59th EVE IWG Session – Hybrid

UN HDV Battery Durability Open Points:

OICA comments on JRC draft

Annex 3 Test procedure and determination of performance parameters

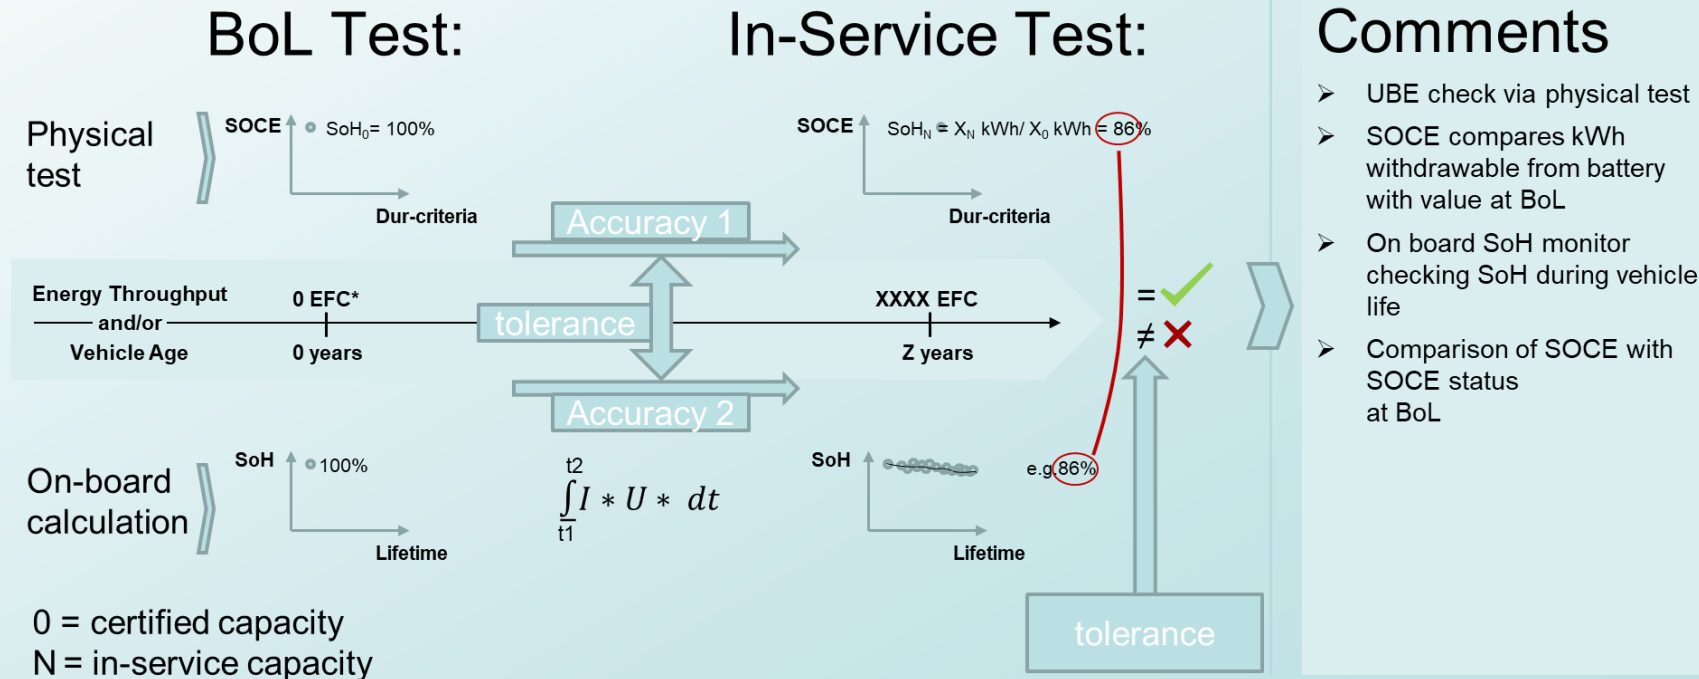
Most time consuming for drafting group.
 Parallel elaboration at OEMs facilities
 necessary / helpful.
